# Access Compliance Report

## Public Rights-of-Way

### (Curb Ramps)

Intersection ID: 4562	Main Street: MALLARD_CREEK_RD	Cross Street: SUMMERCROFT_LN	Location: NW
ADA ID: 5A4AFA6C84B8	Ramp Type: Perp	Initial Pass/Fail: Fail	Overall Compliance: No
Severity Score: 21.25			
Codes/Mitigation Info/Possible Solution		Field Measurements/Component Compliance

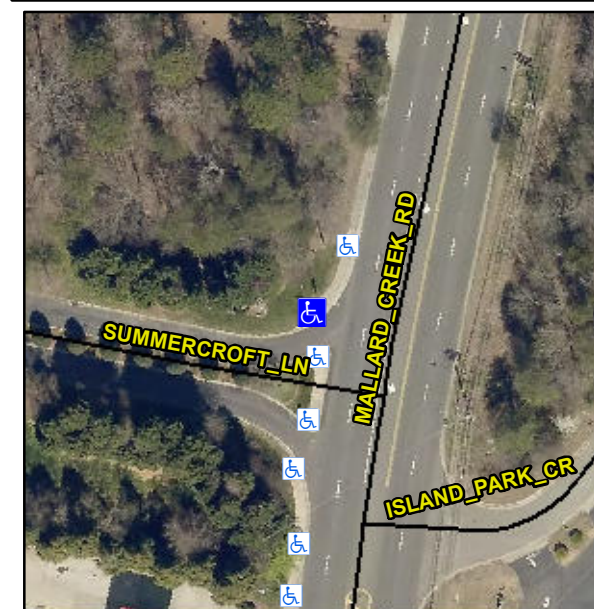
**Not Found, R304.5.1, R304.5.3**

Compliance	Description	Data	Compliance	Description	Data
N/A	Ramp Length (in)	60.0	Yes	Ramp Slope (%)	7.0
No	Ramp Width (in)	42.0	No	Ramp XSlope (%)	5.3
N/A	Flare Type LT	N/A	N/A	Flare Type RT	N/A
N/A	Flare Slope LT (%)	N/A	N/A	Flare Slope RT (%)	N/A
N/A	Flare Traversable LT?	N/A	N/A	Flare Traversable RT?	N/A
N/A	Landing Length (in)	N/A	N/A	DWS Provided?	N/A
N/A	Landing Width (in)	N/A	N/A	DWS Contrast?	N/A
N/A	Landing Slope (%)	N/A	N/A	DWS Length (in)	N/A
N/A	Landing X Slope (%)	N/A	N/A	DWS Full Width?	N/A
N/A	Landing Curb? (Y/N)	N/A	N/A	DWS Offset (in)	N/A
N/A	Shared Landing?	N/A			
N/A	Gutter Ponding?	N/A	N/A	Gutter Slope (%)	N/A
N/A	Gutter Lip Ht (in)	N/A	N/A	Gutter X Slope (%)	N/A
N/A	Painted X Walk1?	No	N/A	Painted X Walk2?	N/A
	X Walk 1 Direction	To S		X Walk 2 Direction	N/A
N/A	X Walk 1 Width (in)	N/A	N/A	X Walk 2 Width (in)	N/A
	X Walk 1 Slope (%)	4.1		X Walk 2 Slope (%)	N/A
	X Walk 1 X Slope (%)	0.3		X Walk 2 X Slope (%)	N/A

**Remove & Replace Entire Ramp.**
